<b>Well Name:</b> WELLER 21 16 FEDERAL COM	<b>Well Location:</b> T25S / R27E / SEC 21 / NWSE / 32.112119 / -104.194896	<b>County or Parish/State:</b> EDDY / NM
<b>Well Number:</b> 274H	<b>Type of Well:</b> OIL WELL	<b>Allottee or Tribe Name:</b>
<b>Lease Number:</b> NMNM107369	<b>Unit or CA Name:</b> WHITE CITY 21 25 27 FED COM 6H	<b>Unit or CA Number:</b> NMNM135716
<b>US Well Number:</b> 3001556278	<b>Operator:</b> CHEVRON USA INCORPORATED

**Type of Submission:** Notice of Intent

**Type of Action:** APD Change

**Procedure Description:** CHEVRON USA, INC. REQUESTS THE FOLLOWING: WELLER 21 16 FEDERAL COM 274H / API # 30-015-56278 CHEVRON REQUESTS TO MOVE THE WELLBORE TWO MILES EAST (PLEASE SEE REVISED C-102'S ATTACHED) CHEVRON REQUESTS TO CHANGE THE DRILLING DESIGN FROM A FOUR-STRING DESIGN TO A 3-STRING DESIGN (PLEASE SEE REVISED 9-POINT PLANS ATTACHED)

WELLER 21 16 FEDERAL COM NO. 274H WELL

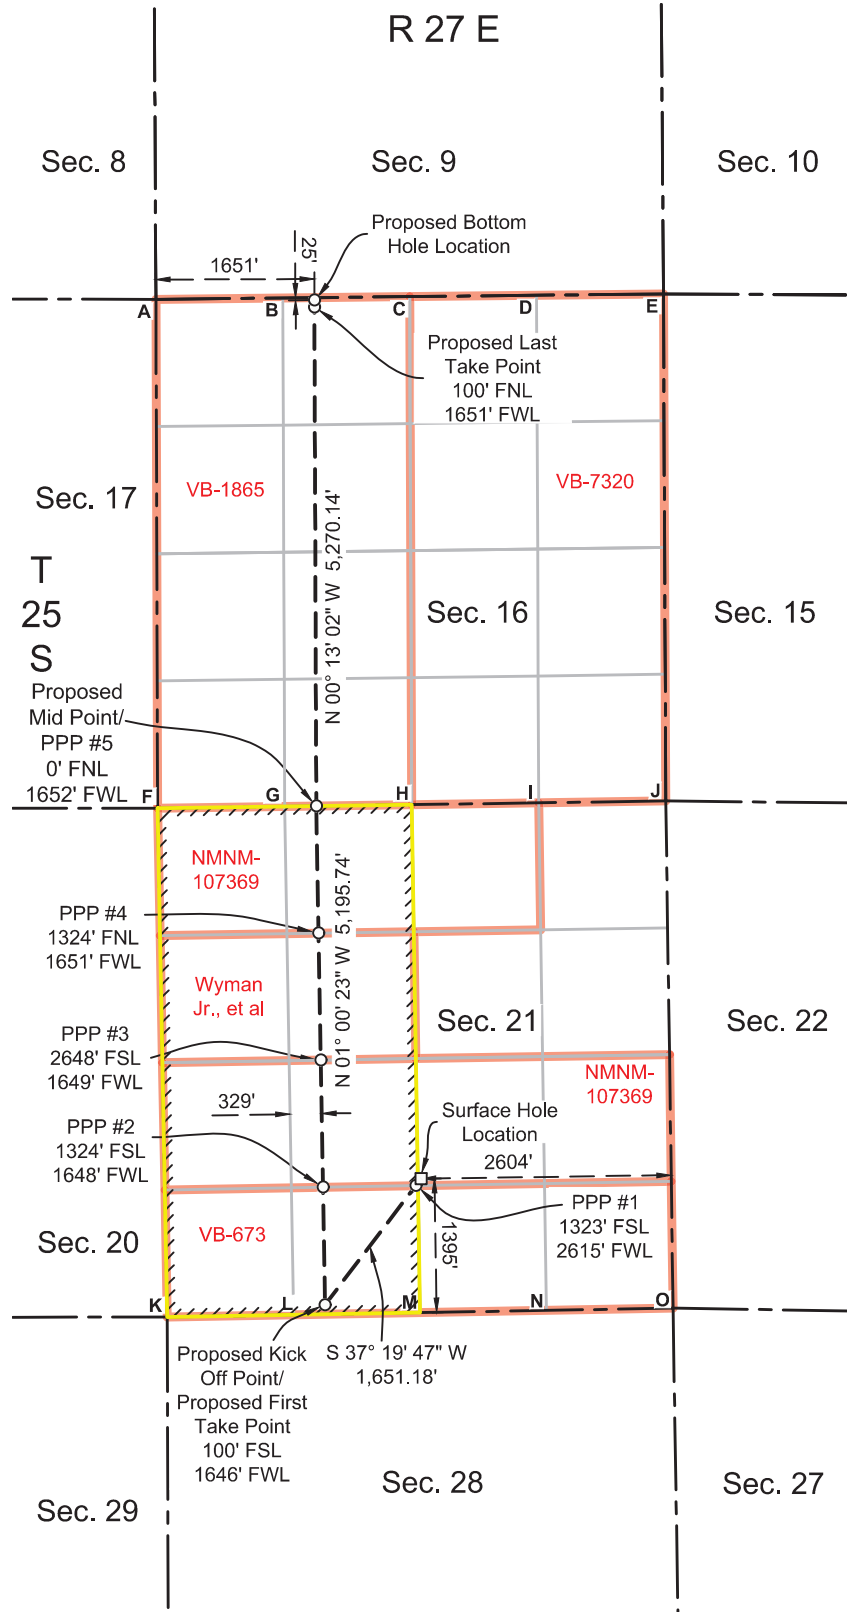
CHEVRON REQUESTS TO MOVE THE WELLBORE TWO MILES EAST (PLEASE SEE REVISED C-102'S ATTACHED)
